Product Service Group CE Audio

Service Information

CORRECTION TO SERVICE MANUAL

CHANGES DURING PRODUCTION

FRONT DISPLAY BOARD - CIRCUIT DIAGRAM

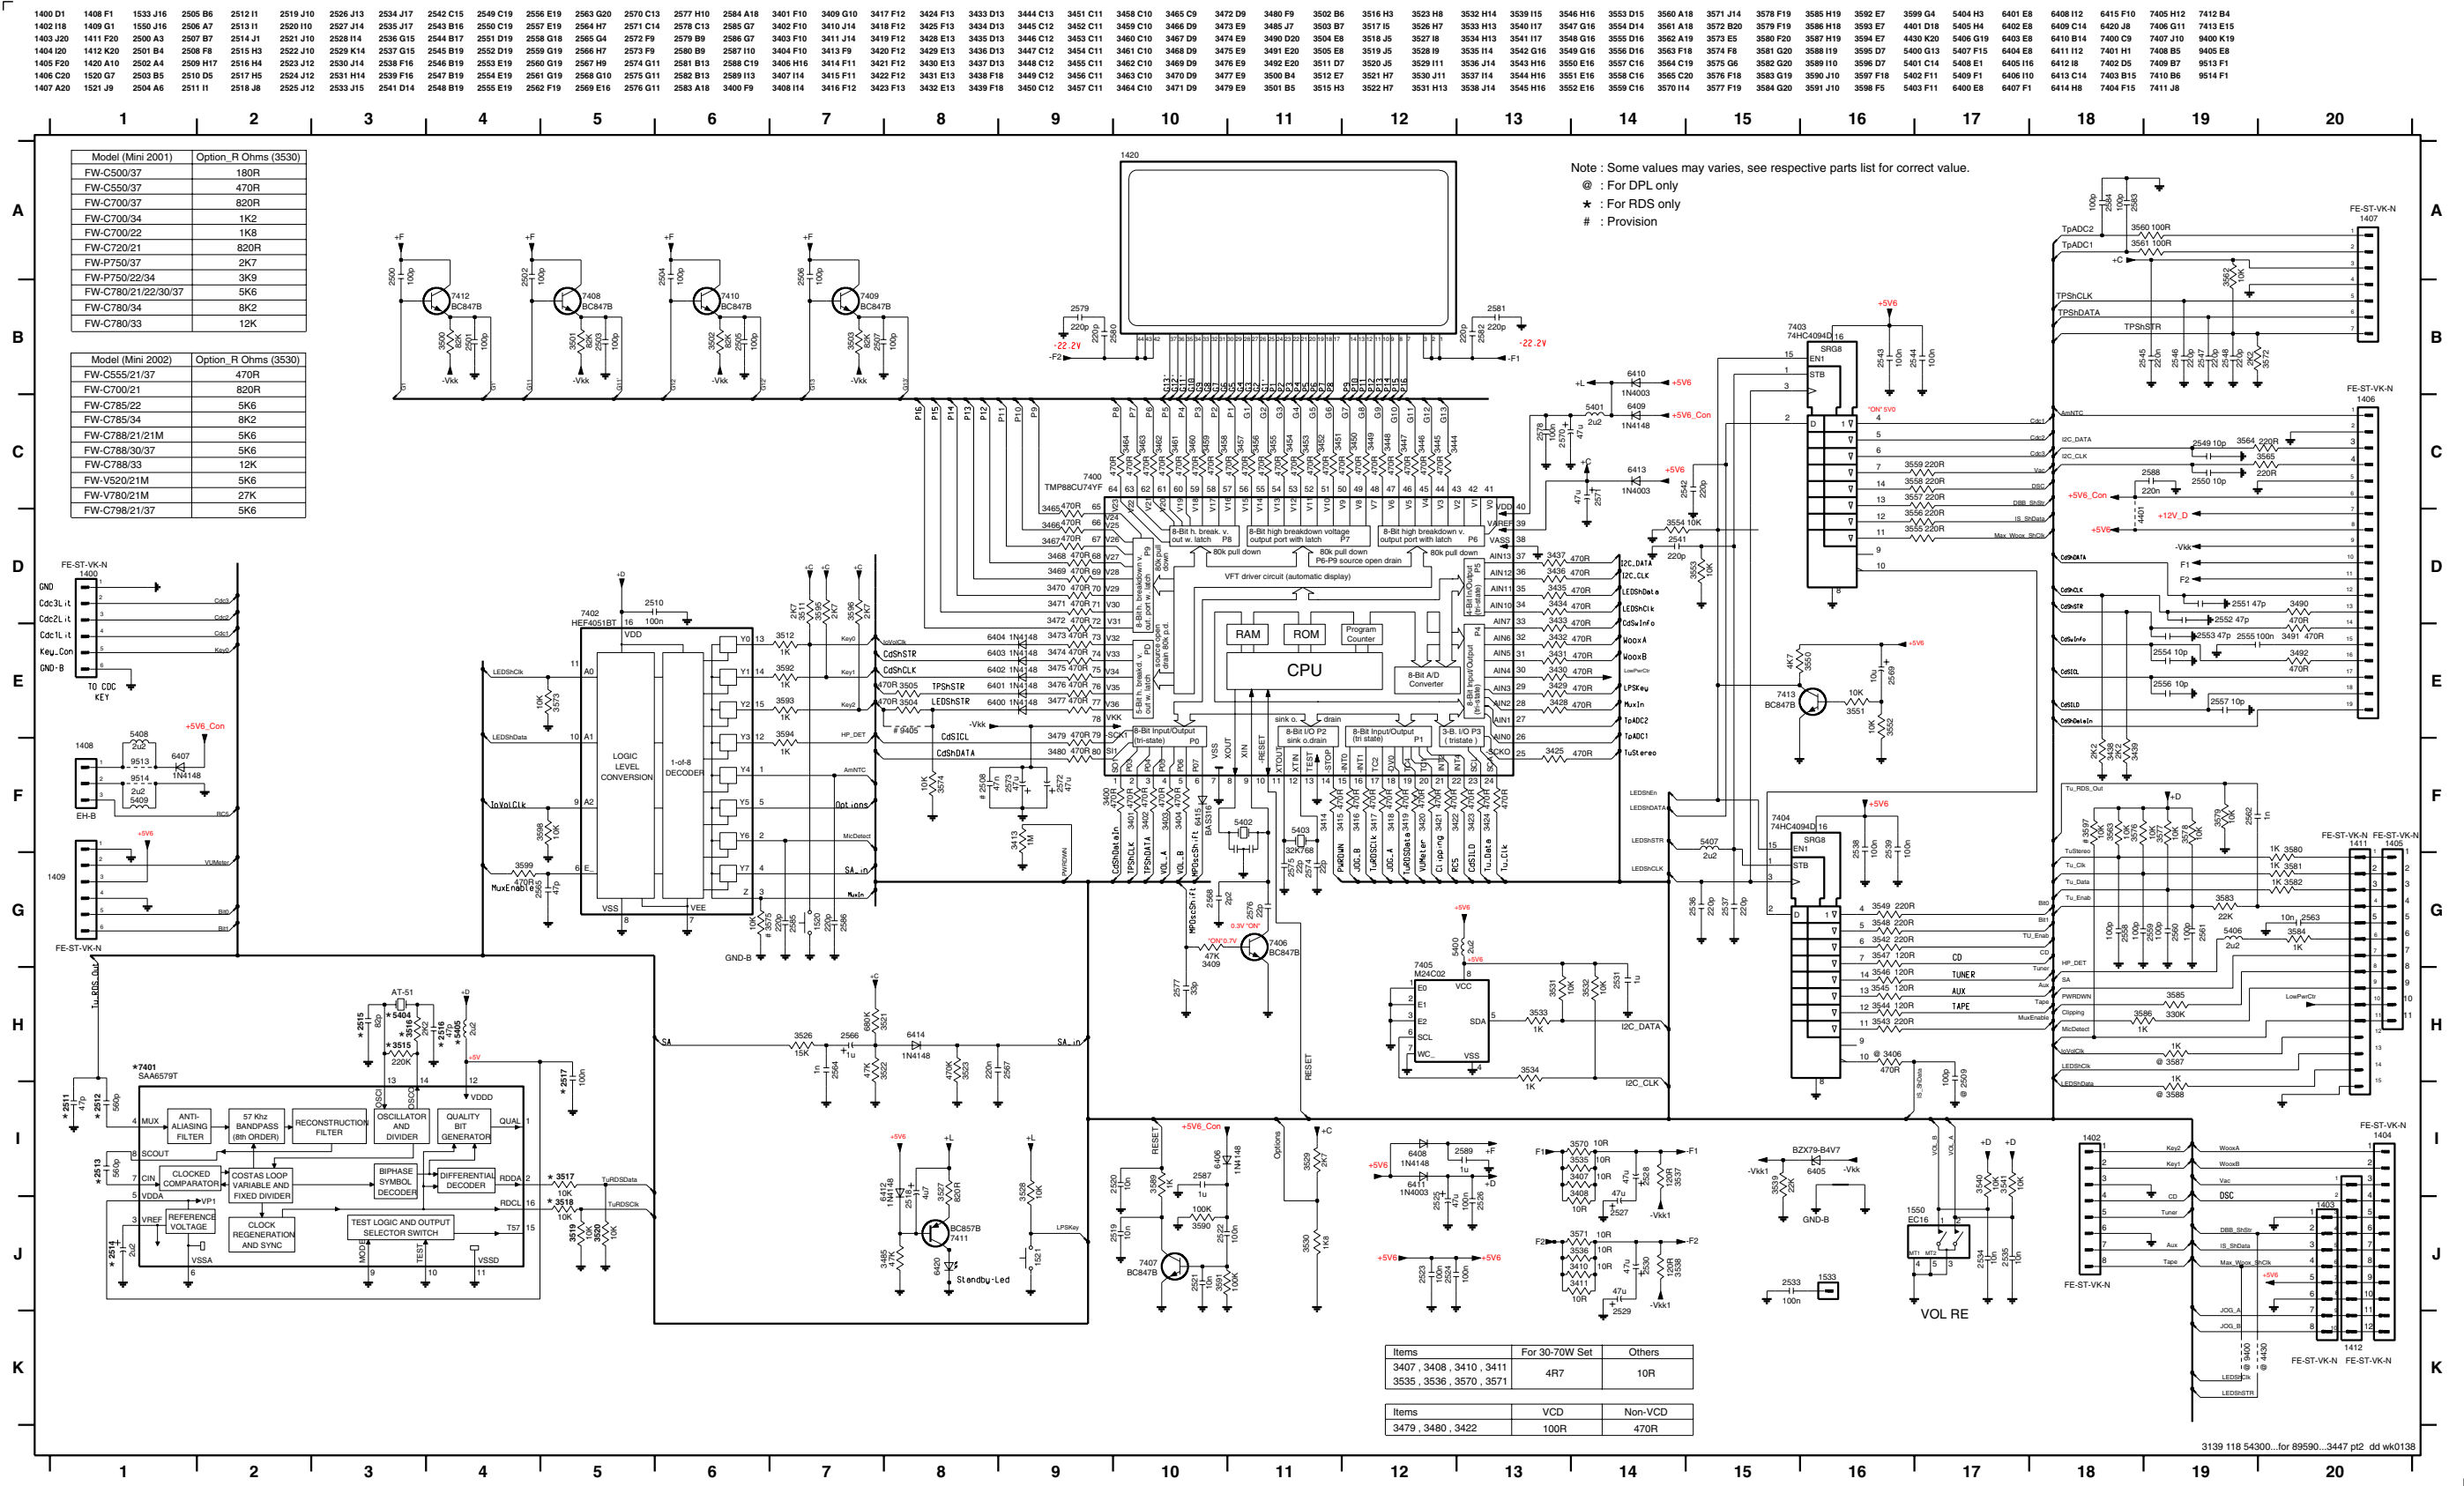
*From production week 0110 onwards pt.2 Board (identified by the last digit of the 12NC - 3139 113 34472) is introduced. For this reason new layout and circuit drawing are enclosed.

Reason : Solution for tuner-locking issue.

Add 6415 4822 130 11397 BAS316
Change 3409 4822 117 12925 47k 1% 0,063W
Delete 3405

Reason : ESD solution.

Add 2585 4822 126 13883 220pF 5% 50V
2586 4822 126 13883 220pF 5% 50V
2587 3198 017 41050 1uF 10V
2588 4822 126 13879 220nF +80/-20% 16V
2589 3198 017 41050 1uF 10V
5408 4822 157 62552 Coil 2,2uH 5%
5409 4822 157 62552 Coil 2,2uH 5%
Change 2563 5322 126 11583 10nF 10% 50V
Delete 9513, 9514 Bare wires

AF9 BOARD

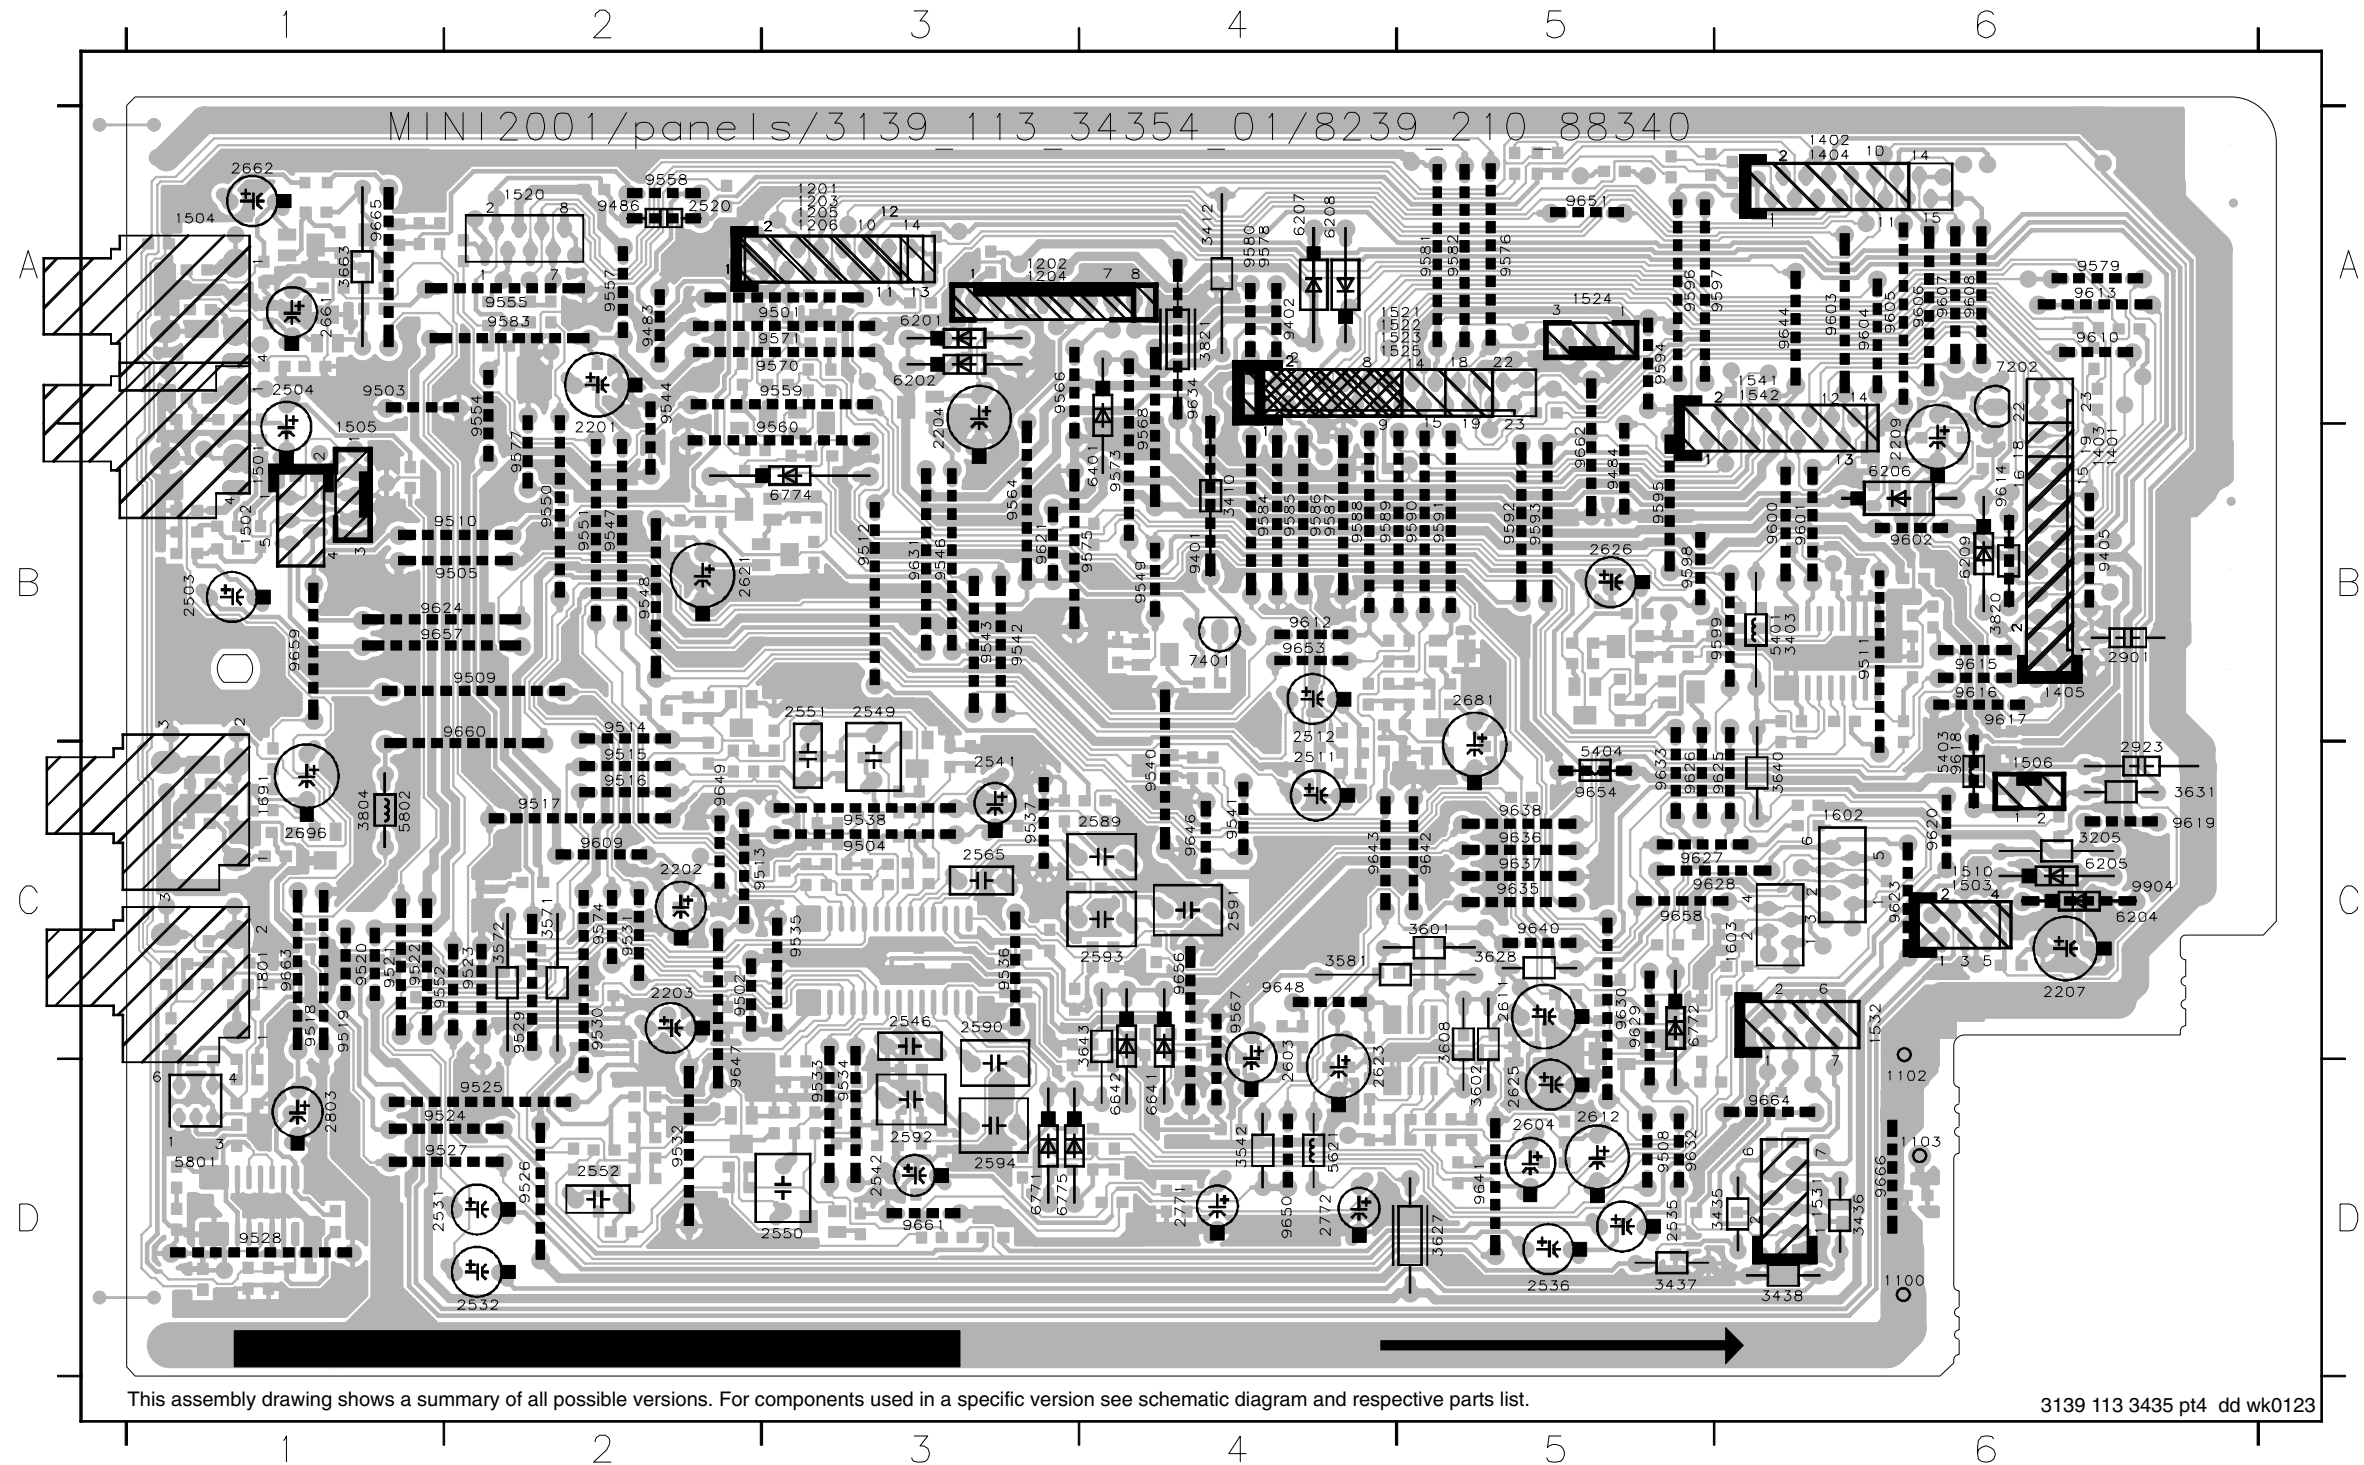
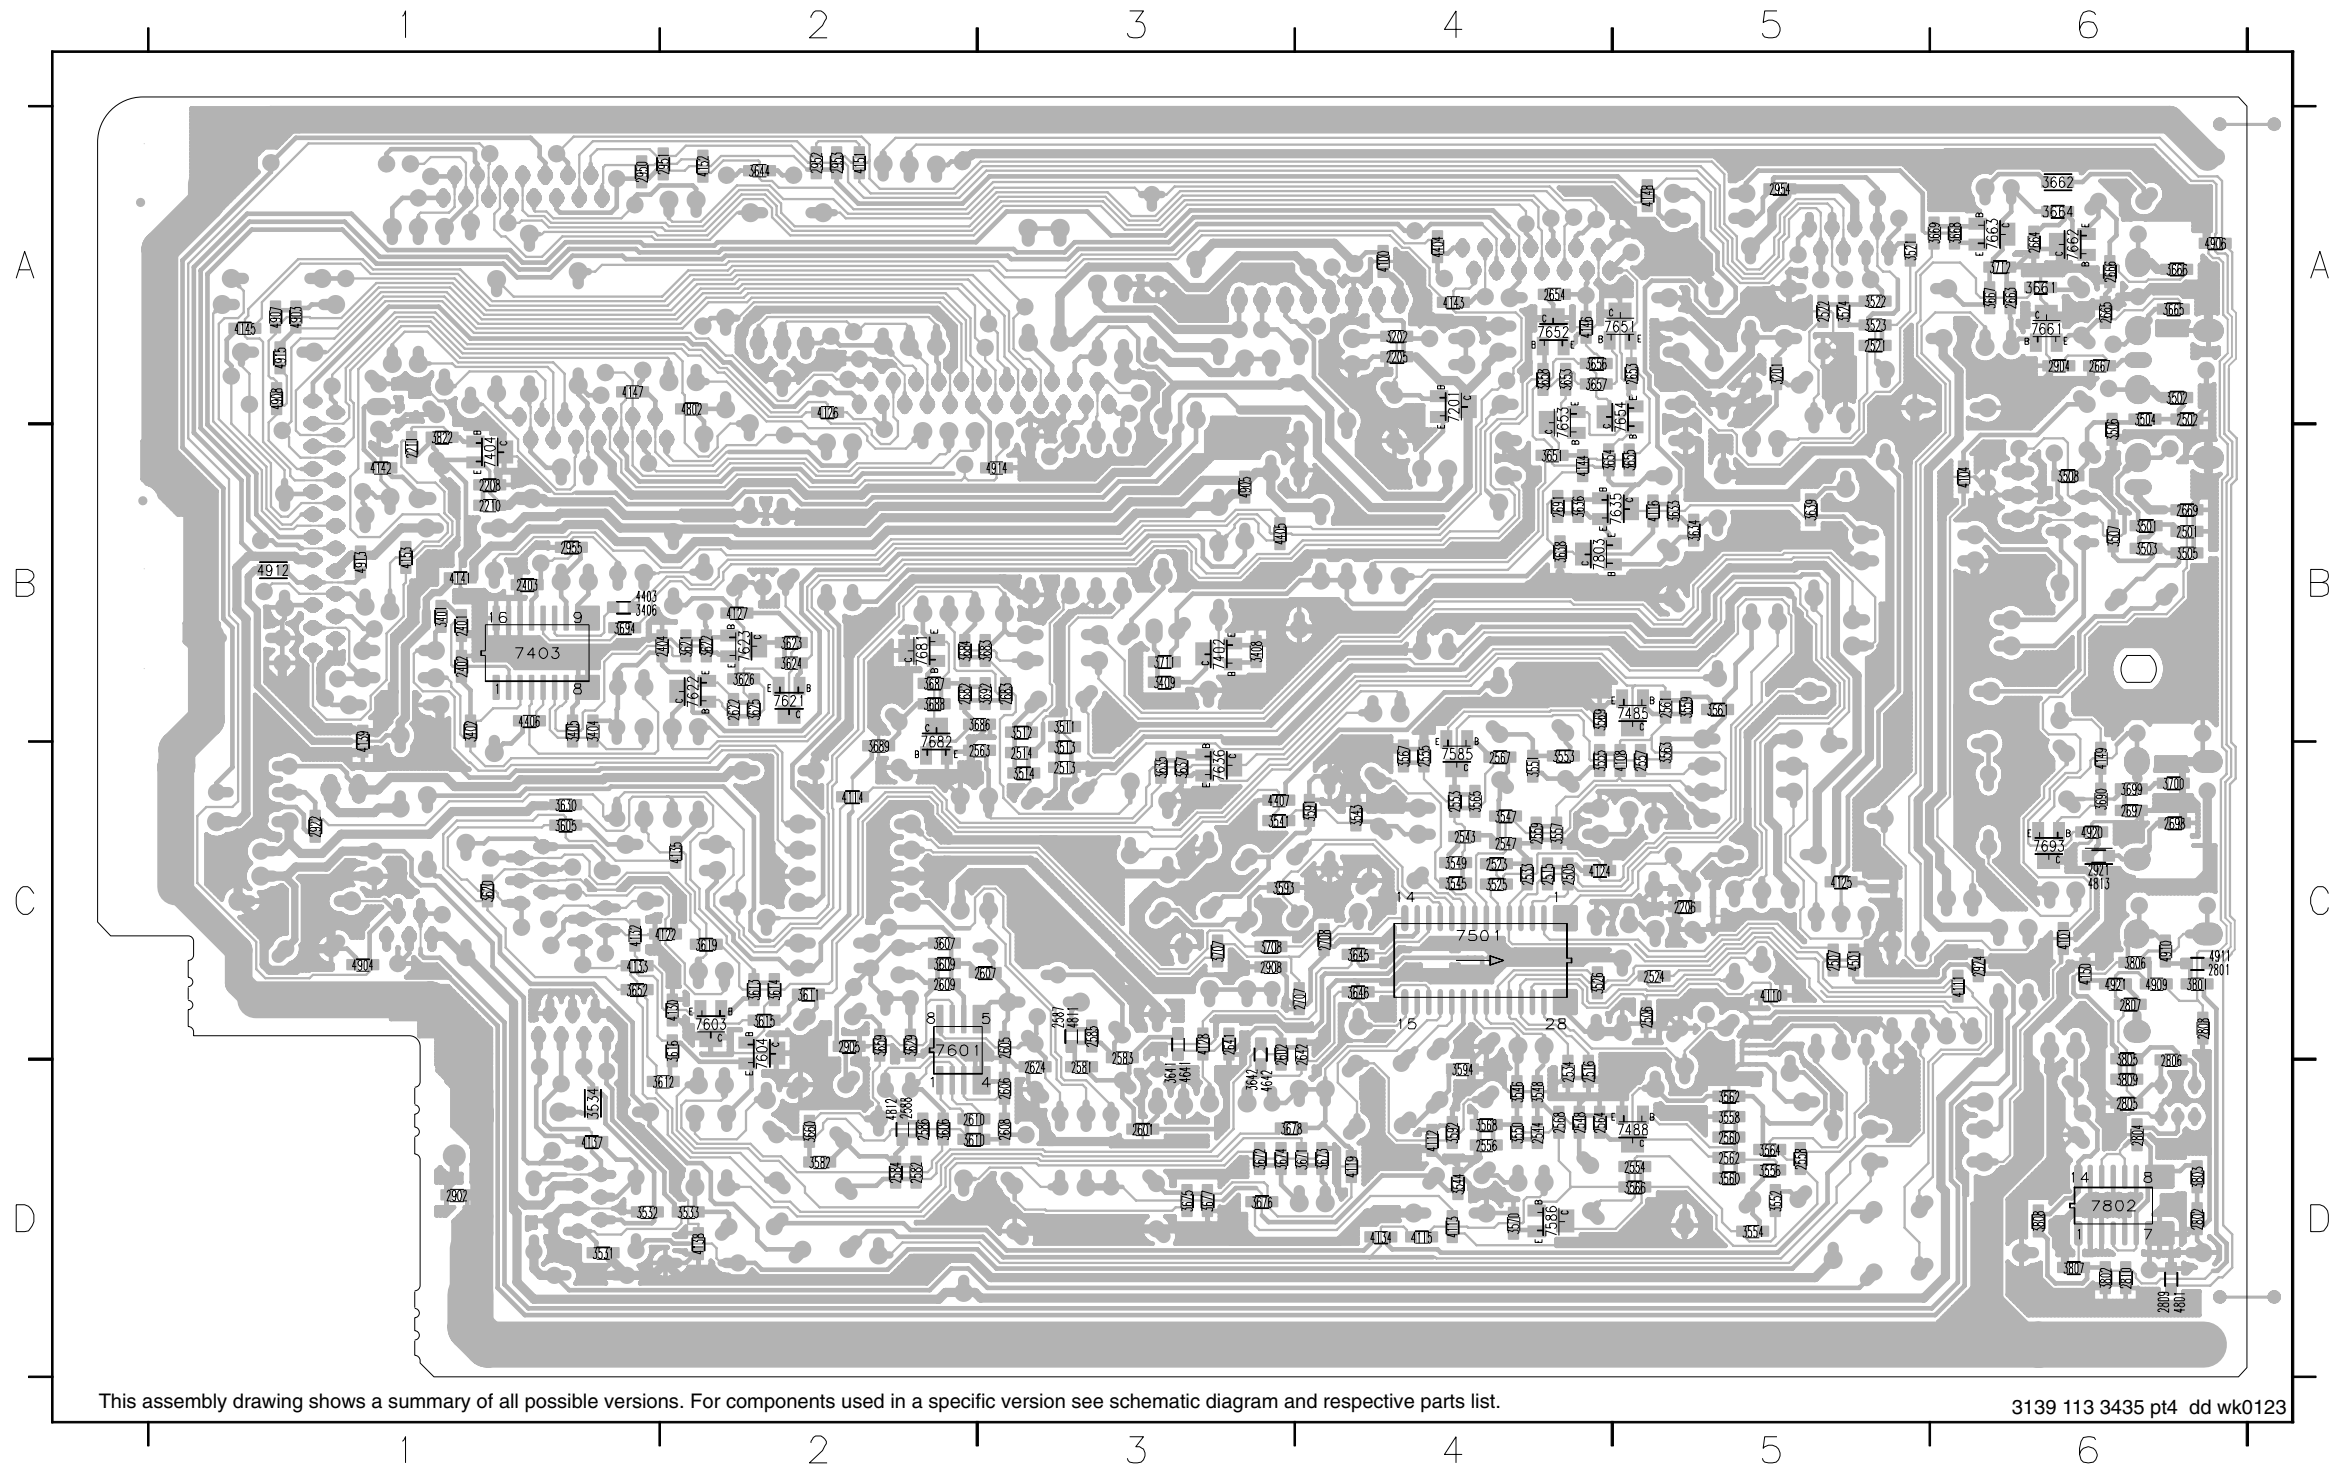
*From production week 0110 onwards pt.3 Board (identified by the last digit of the 12NC - 3139 113 34353) is introduced.

Reason : For process, EMC & ESD improvement.

Add 2950 4822 126 13881 470pF 5% 50V
2951 4822 126 13881 470pF 5% 50V
2952 4822 122 31765 100pF 2% 63V
2953 4822 126 13881 470pF 5% 50V
3820 4822 116 52176 10R 5% 0,5W
4921 4822 051 30008 0R Jumper 0603
Change 6206 4822 130 31878 1N4003G
Delete 9614 Bare wire

*From production week 0122 onwards the following has been changed for GSM solution.

Add 3525 4822 051 30471 470R 5% 0,062W
3526 4822 051 30471 470R 5% 0,062W
3645 4822 051 30221 220R 5% 0,062W
3646 4822 051 30221 220R 5% 0,062W
4153 4822 051 30008 0R Jumper 0603
4641 4822 051 30008 0R Jumper 0603
4642 4822 051 30008 0R Jumper 0603
Delete 3641, 3642

*From production week 0133 onwards the following has been changed to solve capacitor current leakage issue.

Change 2503 4822 124 22466 1uF 20% 50V
2504 4822 124 22466 1uF 20% 50V
2511 4822 124 22466 1uF 20% 50V
2512 4822 124 22466 1uF 20% 50V

*During production pt.4 Board (identified by the last digit of the 12NC - 3139 113 34354) is introduced. For this reason new layout and circuit drawing are enclosed.
